Contract #: 04-0120F4Cty: SF/ALA Rte: 80 PM: 13.2/13.9File #: 69.25B**QUALITY ASSURANCE -- NON-CONFORMANCE REPORT****Location:** Changxing Island, Shanghai, P.R. China**Report No:** NCR-000556**Prime Contractor:** American Bridge/Fluor Enterprises, a JV**Date:** 22-Dec-2009**Submitting Contractor:** Zhenhua Port Machinery Company, Ltd (ZPMC), Changxing Island**NCR #:** ZPMC-0529**Type of problem:****Welding****Concrete****Other****Welding****Curing****Procedural****Bridge No:** 34-0006**Joint fit-up****Coating****Other****Component:** OBG Segments 6AW/6BW**Procedural****Procedural****Description:****Reference Description:** Base Metal Repairs without Engineer's Approval, Segments 6AW/6BW**Description of Non-Conformance:**

Job Name: SAS Superstructure

Reference Description: Base Metal Repairs without Engineer's Approval, Segments 6AW/6BW

Reference Description: Base Metal Repairs without Engineer's Approval, Segments 6AW/6BW

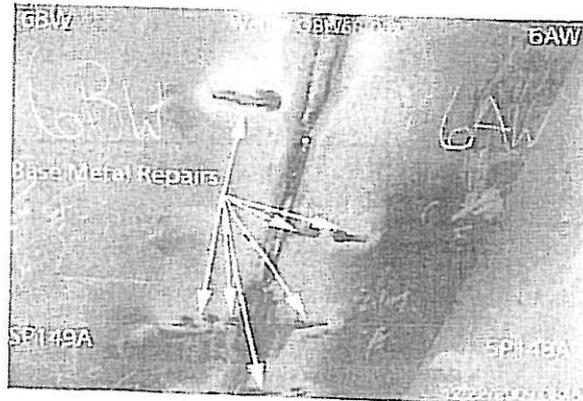
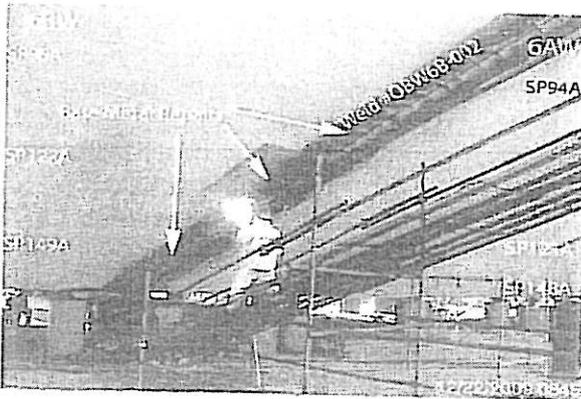
The Caltrans Quality Assurance (QA) Inspector observed Base Metal Repairs were performed without prior approval from the Engineer. Base Metal Repairs were performed using the Shielded Metal Arc Welding (SMAW) process where temporary fit up attachments were removed in multiple locations at the 6AW/6BW Side Plate Segment splice, weld # OBW6B-002 (counter weight side).

The following Side Plates were repaired:

For 6AW: SP148A, SP121A, SP94A

For 6BW: SP149A, SP122A, SP95A

AWS D1.5-2002 Section 3.7.4; "Prior approval of the Engineer shall be obtained for repairs to base metal"

Contractor submitted WRR used for base metal repairs along with subsequent NDT records verifying the repairs are in conformance with Contract specifications.

项目名称 Project Name	美国海湾大桥 SFOBB	部件图号 Drawing No	OB6W(E)/OB7W(E)	报告编号 Report No.	B-WR9815
合同号 Contract No.:	04-0120F4	部件名称 Items Name	底板、非联系梁侧斜底板及腹板、顶板Side plate and side plate, edge plate, deck plate	NDT报告编号 Report No.of NDT	NA
项目编号 Project No.:	ZP06-787

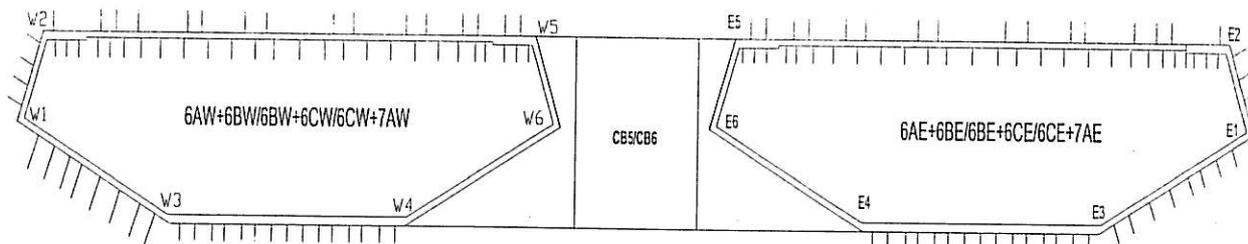
经检查发现西线6AW+6BW/6BW+6CW/6CW+7AW及东线6AE+6BE/6BE+6CE/6CE+7AE吊装段底板、非联系梁侧斜底板及腹板,顶板马板去除后母材需修补。具体位置见下图所示:

After inspection west linear 6AW+6BW/6BW+6CW/6CW+7AW and east linear 6AE+6BE/6BE+6CE/6CE+7AE lifting bottom plate and side plate, edge plate without face strut plate, deck plate, the base metal was gouged after removing temporary attachment, the detail sees the following draft.

工人操作失误, 导致母材损伤。

Worker operator error caused base metal gouged.

1. QC和CWI在整个修补过程中都应在场并指导以确保返修按照处理意见以及AWS D1.5要求进行;
 2. 按照焊接返修工艺规程 (WPS) 打磨缺陷区域至光滑;
 3. 准备一个正确的接头形式, 具体参见返修的WPS;
 4. 在NDT检测前口头通知QA。对返修区域作100%MT和100%VT检查;
 5. 如果仍发现有缺陷, 通过打磨的方法去除所有缺陷以确认缺陷完全被清除, 并重复第四步以确认缺陷完全被清除;

6. 将杂物以及MT检测遗留的残留物清理干净;
 7. 根据批准的焊接返修工艺规程 (WPS) 进行预热及焊接;
 8. 将焊接区域打磨至与母材平齐;
 9. 在NDT检测前口头通知QA。对返修区域作100%MT和100%VT检查。
-
1. QC and CWI should be present to witness the repair, direct and supervise all repair operations during this repair to ensure the repair is per the disposition requirements, and the AWS D1.5 code requirements.

2. Grind the repair area to a smooth finish according to the approved repair WPS.
 3. Prepare the joint according to the approved WPS.
 4. Notify QA verbally prior to NDT. Perform 100%MT and 100%VT of the repair area.

5. Remove all defects by grinding to ensure all defects are completely removed if defects still exist, and repeat "step 4" to assure complete removal of all defects if necessary.

6. Clean the repair area of all loose debris including MT powder.
 7. Preheat and weld according to the approved WPS.
 8. Grind the weld flush after welding.

9. Notify QA verbally prior NDT. Perform 100%MT and 100%VT of the repair area.
